COUNTY OF SAN BERNARDINO  
WHITE KNOB/WHITE RIDGE LIMESTONE  
QUARRIES EXPANSION  
FINAL ENVIRONMENTAL IMPACT REPORT

SCH No. 2013061020

**VOLUME 1 - FINAL ENVIRONMENTAL IMPACT REPORT**

2.0 COMMENTS AND RESPONSES TO COMMENTS ON THE DRAFT SEIR

<b>Project</b>		White Ridge Quarry	
<b>Analysis Description</b>		Azimuth 180/Slope Angle 70/Dip Vector Plot/Wedge Sliding Evaluation	
<b>Drawn By</b>	CHJ	<b>Author</b>	JMC
<b>File Name</b>	White Ridge Set.dips6	<b>Date</b>	8/15/2013
			<b>Enclosure</b> B-1.2

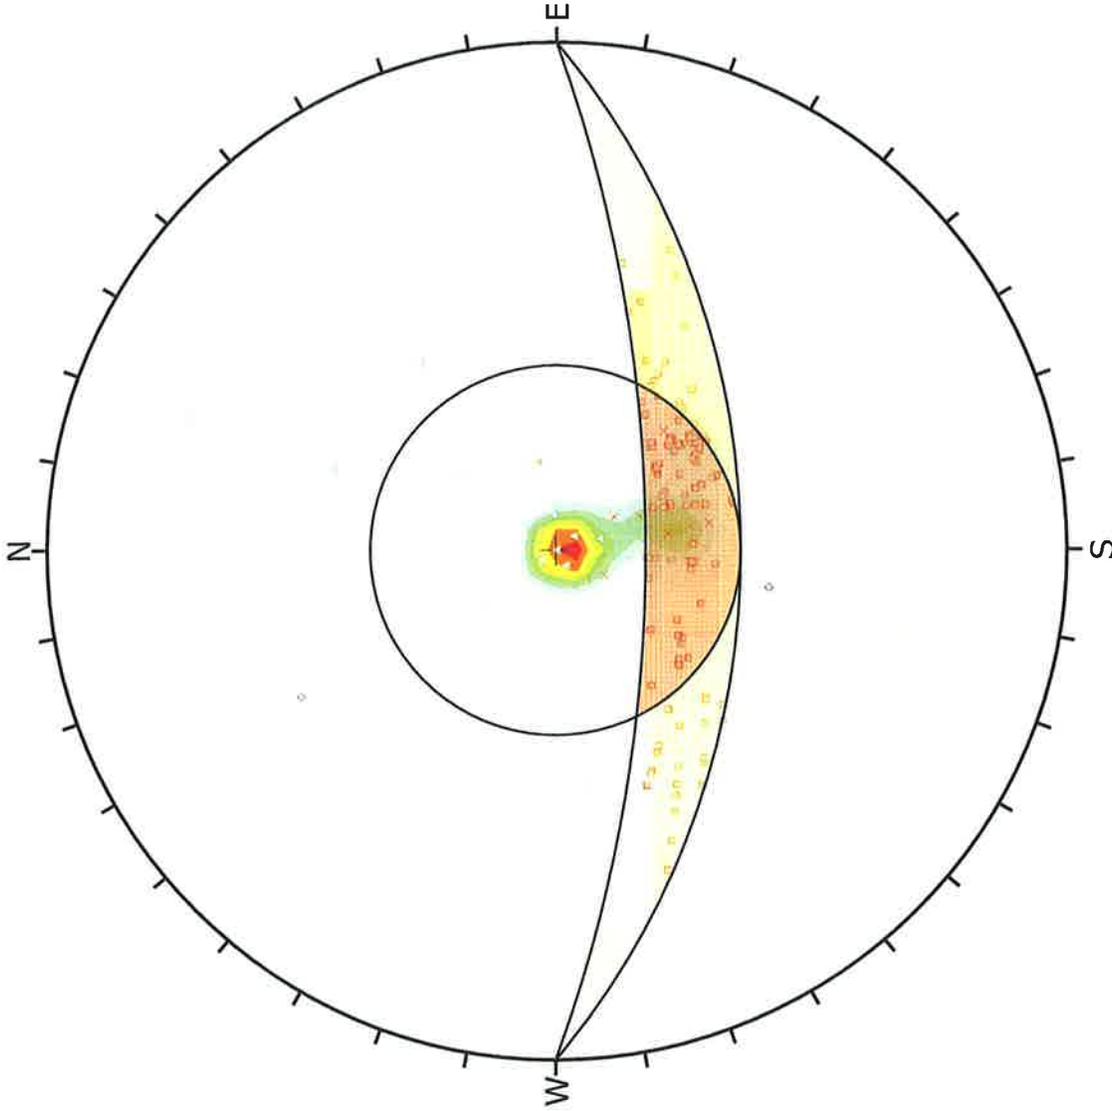
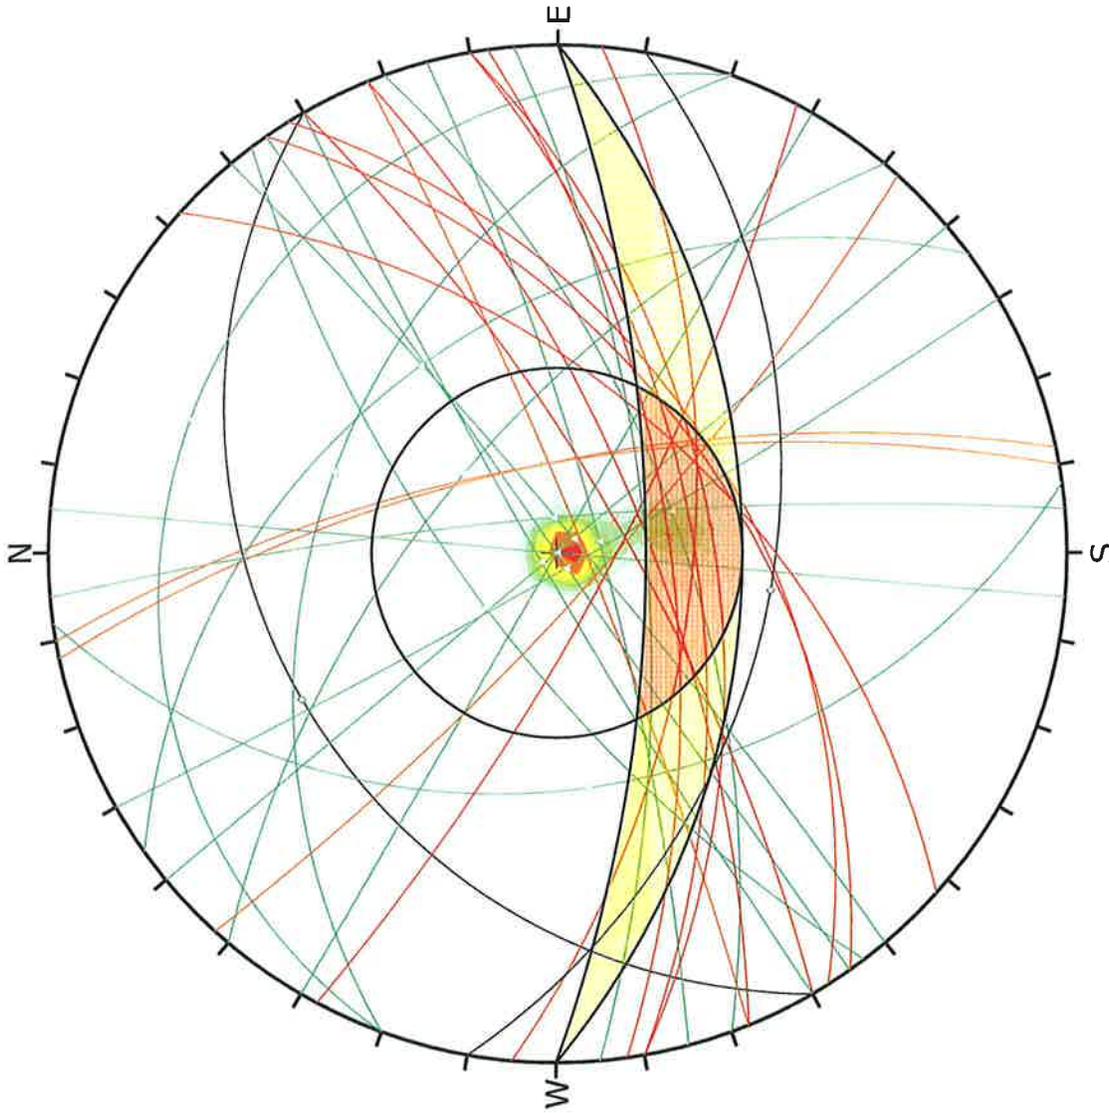
*Enclosure B-4.0 – This analysis is only for planar failures. The figure also appears to show two wedge failure intersections within the critical zone. One intersection comes from a joint and a foliation and the other for two joints. A discussion is needed on why these intersections were not included in the analysis.*

Figures B-1.1 and B-1.2 provide an alternate depiction of the discontinuity data for the White Ridge quarry as a wedge sliding analysis with a greater statistical emphasis. The plot indicates a significant potential for wedge geometry in south-facing cuts. Current mining practice includes scaling of loose blocks during excavation of final bench faces and inclusion of catch benches in the mining plan. These mitigation measures have resulted in stable wall configurations in the existing White Knob

<b>Project</b>		White Ridge Quarry	
<b>Analysis Description</b>	Azimuth 270/Slope Angle 70/Dip Vector Plot/Wedge Sliding Evaluation		
<b>Drawn By</b>	CHJ	<b>Author</b>	JMC
<b>File Name</b>	White Ridge Set.dips6	<b>Date</b>	8/15/2013
		<b>Enclosure</b>	B-2.2

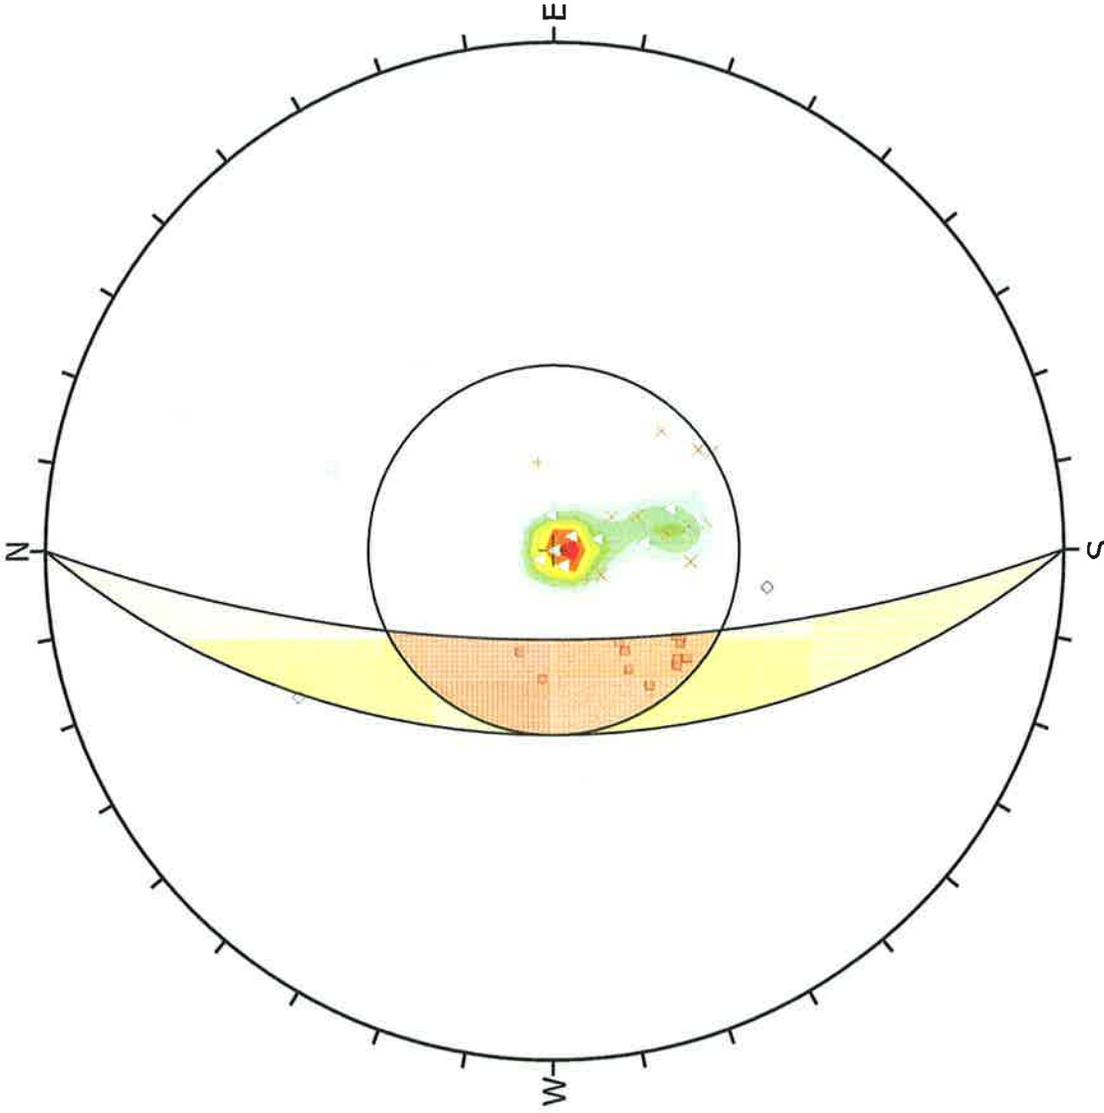
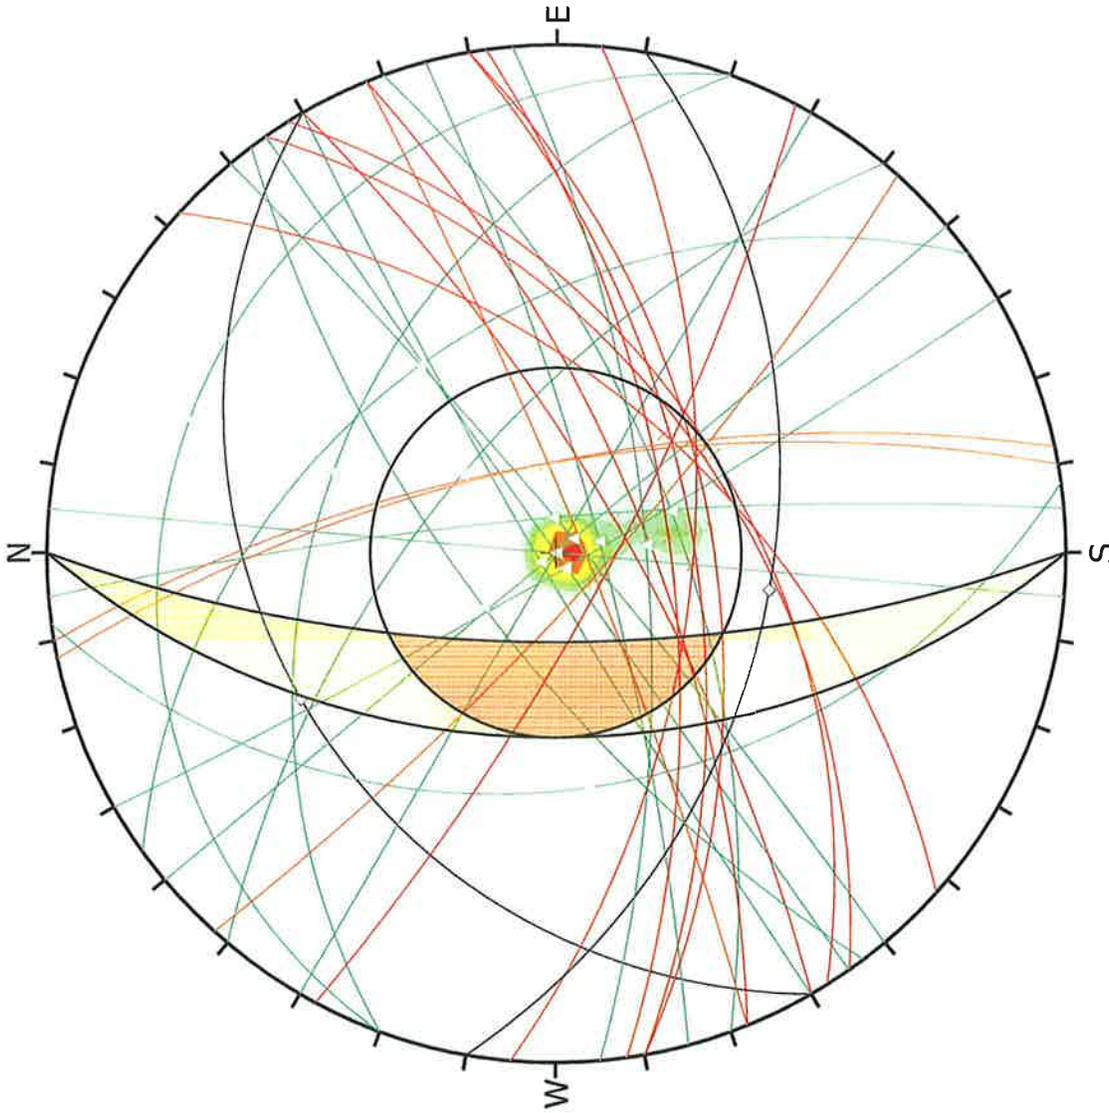
*Enclosure B-5.0 – This analysis is for one wedge failure. The figure appears to show a second wedge failure caused by the intersections of a foliation and a fault within the critical zone. A discussion is needed on why this intersection wasn't included in the analysis.*

Figures B-2.1 and B-2.2 provide an alternate depiction of the discontinuity data for the White Ridge quarry as a wedge sliding analysis with a greater statistical emphasis. Based on the percentage of "critical" features versus the total intersections, the potential for wedge failure in west-facing slopes is low. Current mining practice includes scaling of loose blocks during excavation of final bench faces and inclusion of catch benches in the mining plan. These mitigation measures have resulted in stable wall configurations in the existing White Knob quarry and are anticipated to mitigate potential instabilities in the future White Ridge quarry. In addition, observation of slope conditions by mining personnel and annual inspection by geologic consultants are included in current operations to identify and mitigate instabilities during mining.

<b>Project</b>	White Knob Quarry		
<b>Analysis Description</b>	Azimuth 210/Slope Angle 70/Dip Vector Plot		
<b>Drawn By</b>	CHJ	<b>Author</b>	JMC
<b>File Name</b>	White Knob Set.dips6	<b>Date</b>	8/15/2013
		<b>Enclosure</b>	B-3.1

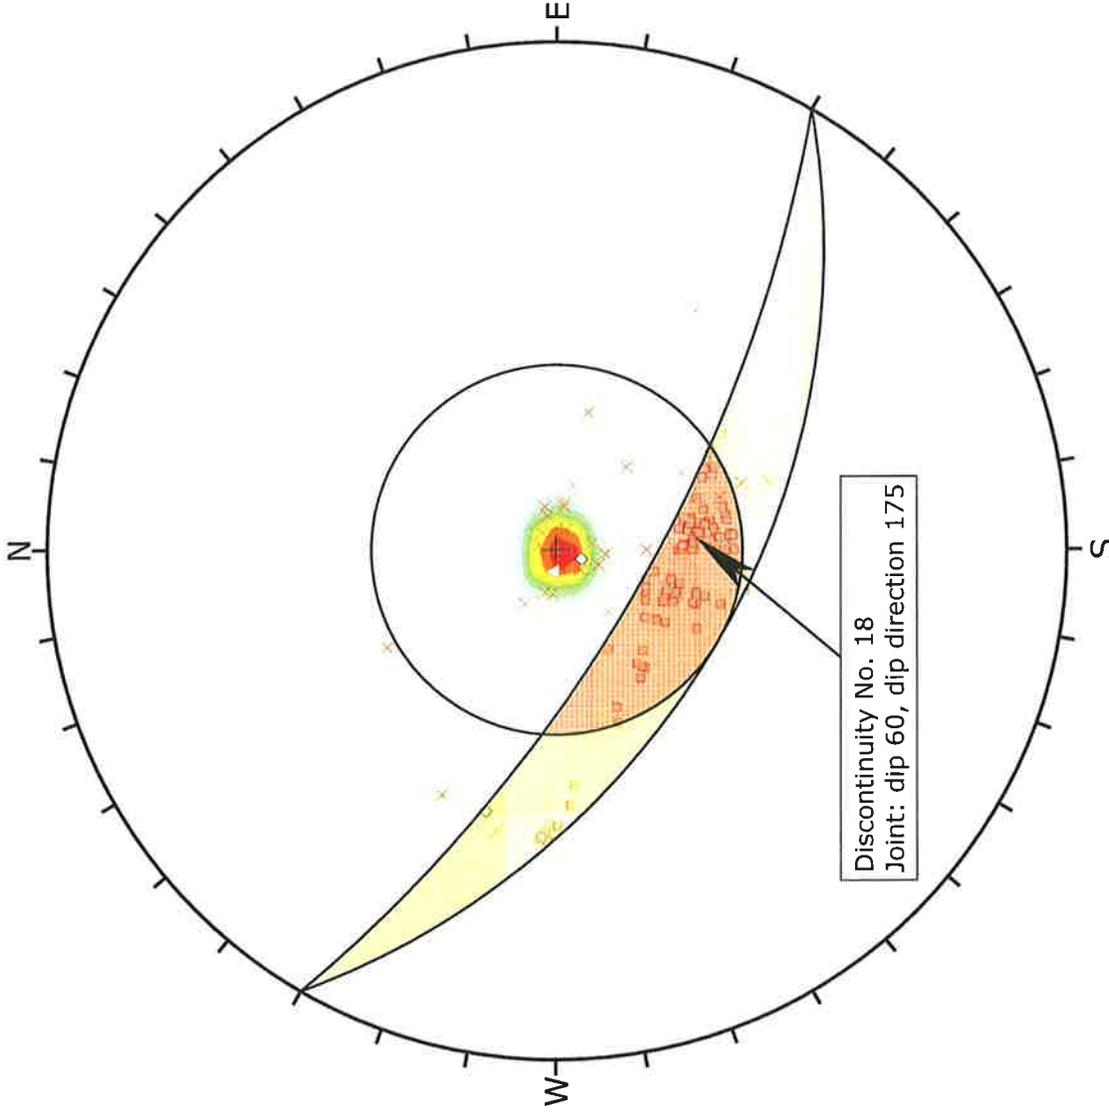
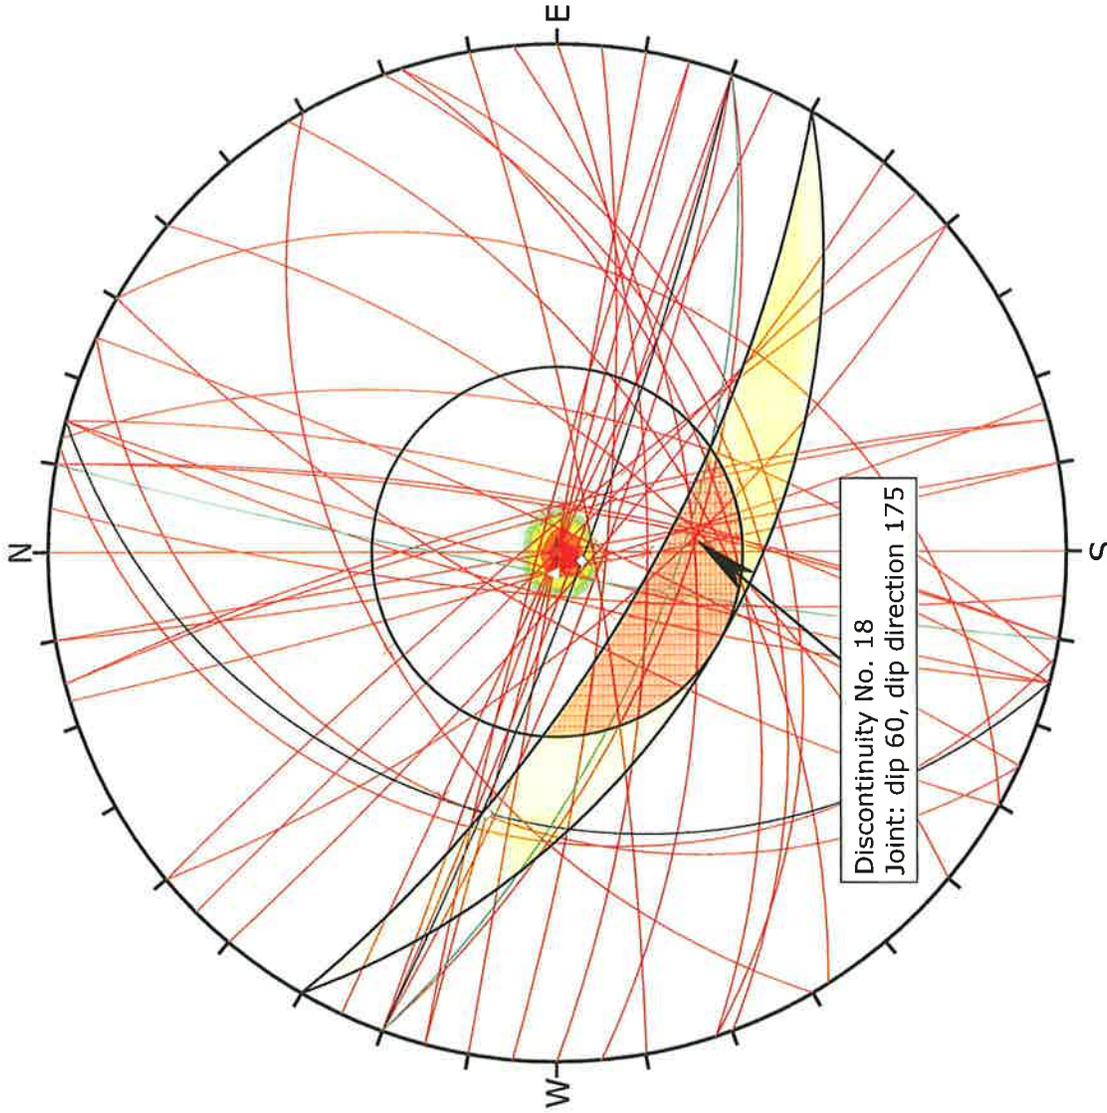
*Enclosure B-9.0 – The plane 2 dip value and dip direction values used in the wedge failure analysis do not appear to be listed in the tables in Enclosure B-1.1 or B-1.2. The failure plane may be an average of several that appear to intersect where plane 2 is shown on the figure. Additional discussion is needed as to why this dip and directional information is provided for the wedge analysis of plane 2.*

The data point referenced in the above comment is Discontinuity No. 18 on Table B-1.1; dip = 60, dip direction = 175, representing a small joint. Figures B-3.1 and B-3.2 provide an alternate depiction of the discontinuity data with No. 18 labeled. According to this depiction, the potential for wedge geometries in southwest-facing slopes of the White Knob quarry is moderate. Empirical data (observation of the existing quarry walls) does not indicate that wedge failure is an issue for the quarry. This observation supports the conclusion that ongoing mining practices produce suitably stable quarry walls with sufficient bench width and spacing to result in a stable reclamation
